**SERVICE BULLETIN**

**N° 139-618**

**ATA 71 – TUNNEL ASSY RETROMOD**

Leonardo Helicopter Division has developed this Service Bulletin in order to perform the installation of the tunnel assy and firewalls retromod P/N 3G7130P01611 and the tunnel assy and firewalls retromod P/N 3G7130P01811.

**Figure 13**

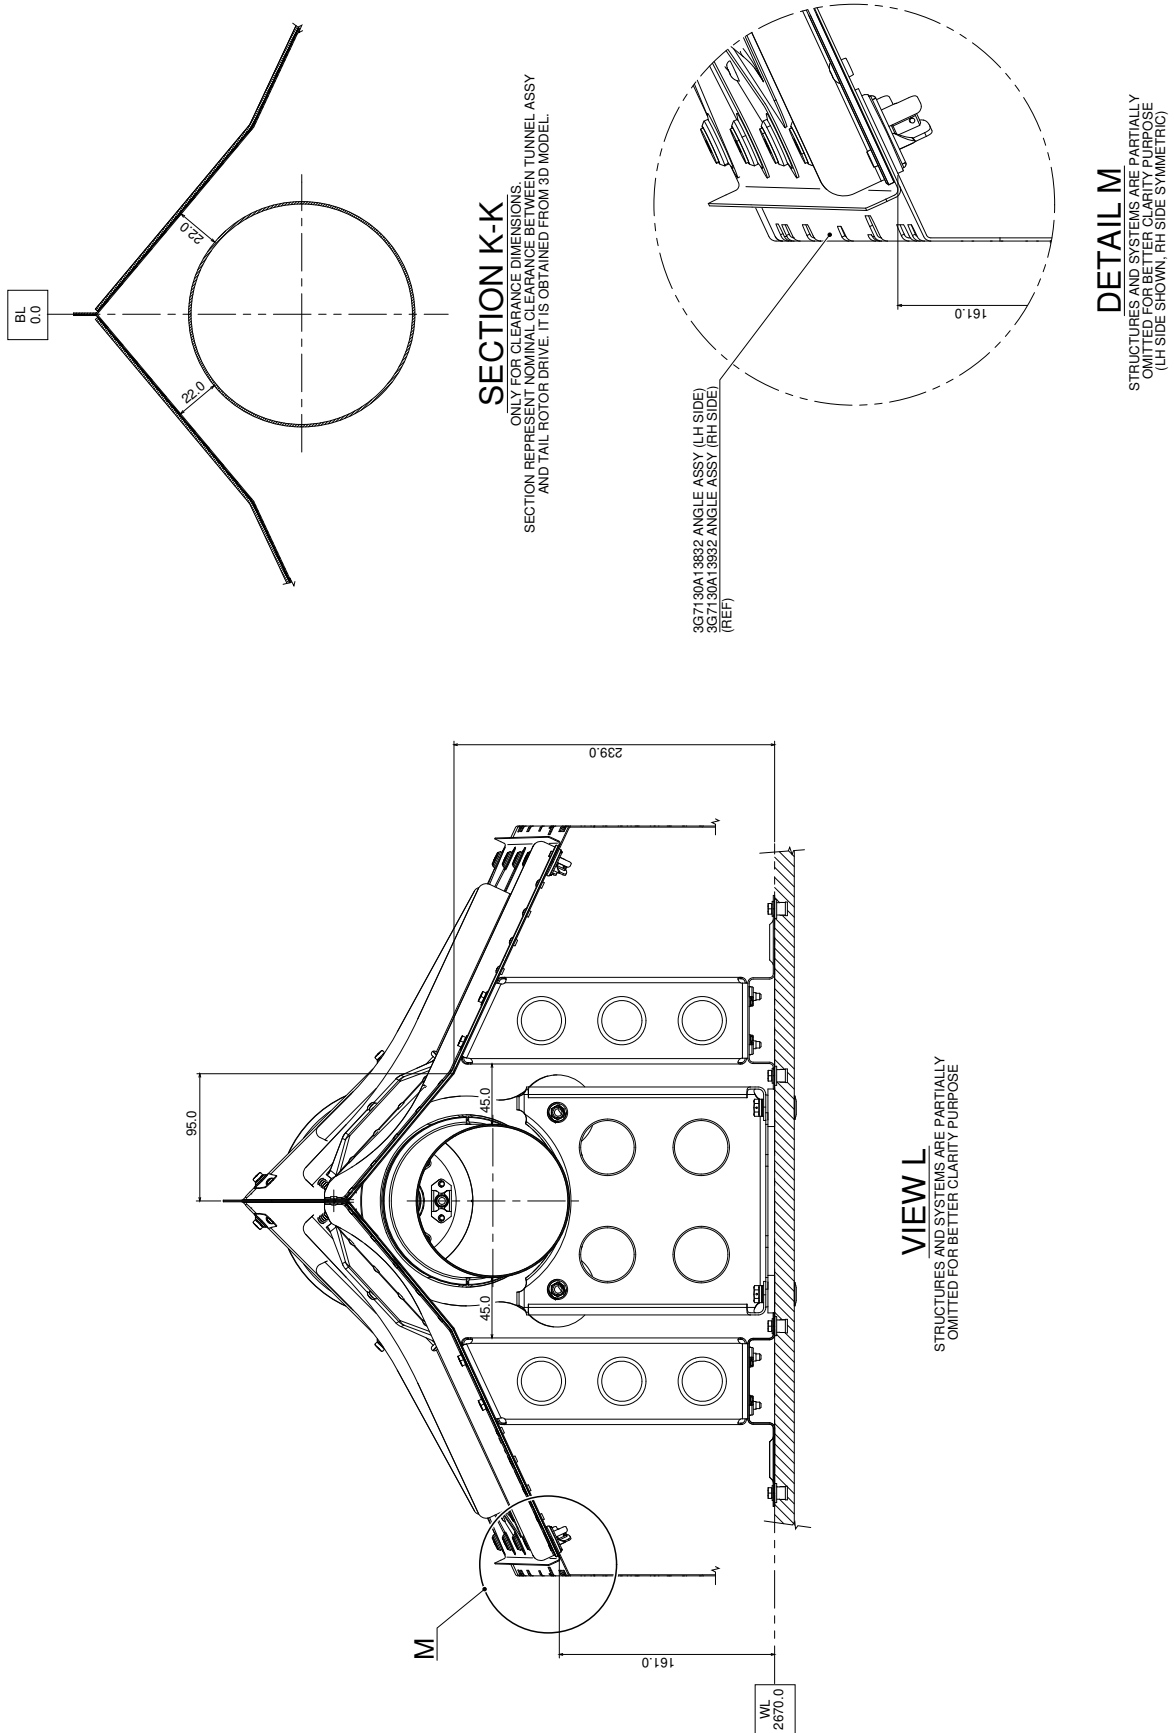
The dimensions reported in Figure 13 Section K-K represent nominal clearances and are mandatory.

- 16.1 With reference to Figure 13 Section K-K, check that the clearance between tunnel assy and tail rotor shaft is as indicated. The allowed tolerance is +/- 2 mm. If the minimum clearances are not met continue to the following step, otherwise skip to step 17.
- 16.2 With reference to Figure 13 View L and Detail M and Figure 14 View J, check the positions of the tunnel assy and the tail rotor shaft. Repeat step 16.1.
17. In accordance with AMP DM 39-C-78-10-04-00A-720A-A, install the previously removed left exhaust duct in its correct position on the helicopter.
18. In accordance with AMP DM 39-C-78-10-06-00A-720A-A, install the previously removed right exhaust duct in its correct position on the helicopter.

- 20.1 With reference to Figure 13 Section K-K, check that the clearance between tunnel assy and tail rotor shaft is as indicated. The allowed tolerance is +/- 2 mm. If the minimum clearances are not met continue to the following step, otherwise skip to step 20.

- 20.2 With reference to Figure 13 View L and Detail M and Figure 14 View J, check the positions of the tunnel assy and the tail rotor shaft. Repeat step 16.1.

**Figure 14**

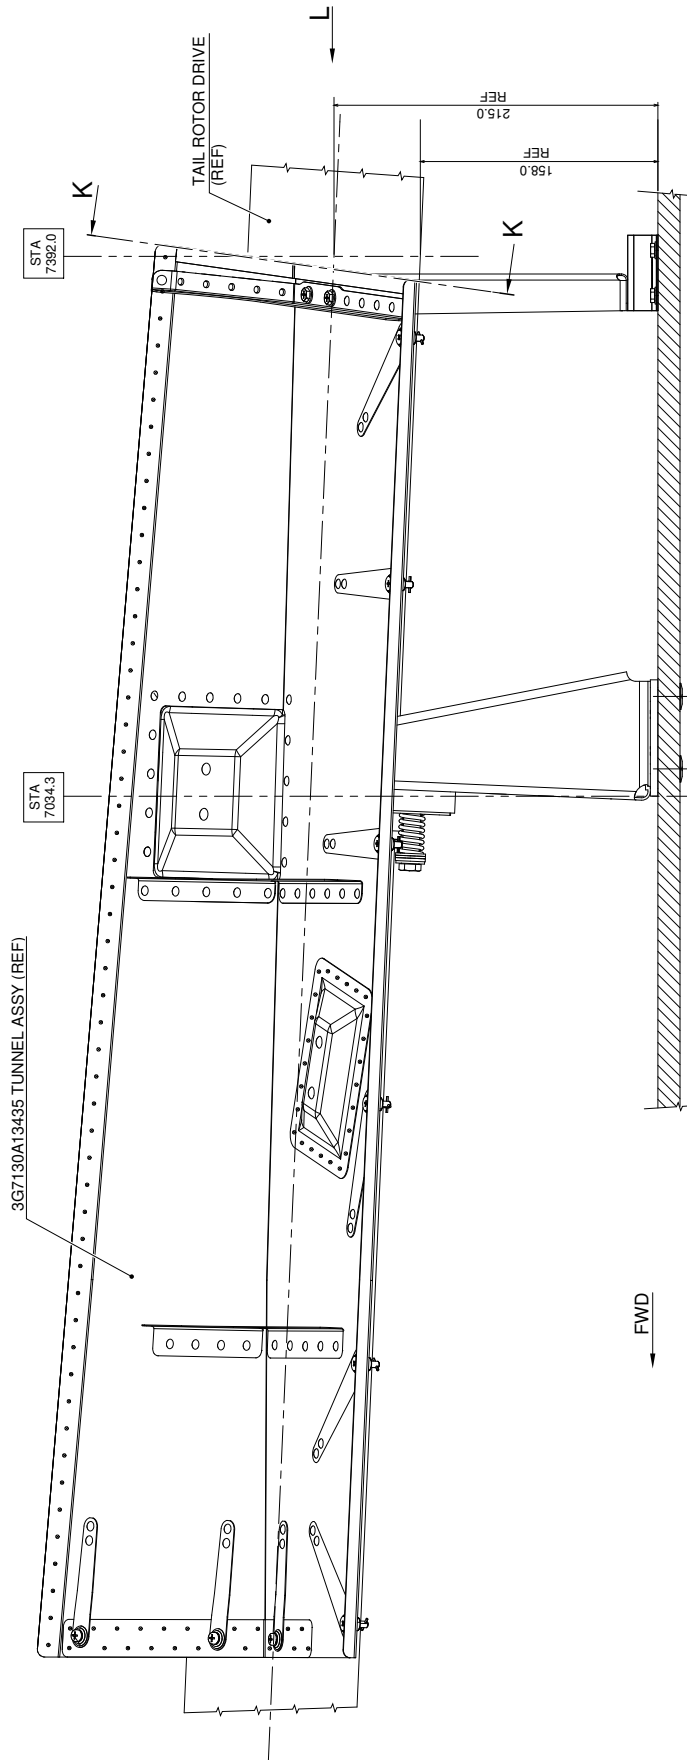
The dimensions reported in Figure 14 Section K-K represent nominal clearances and are mandatory.
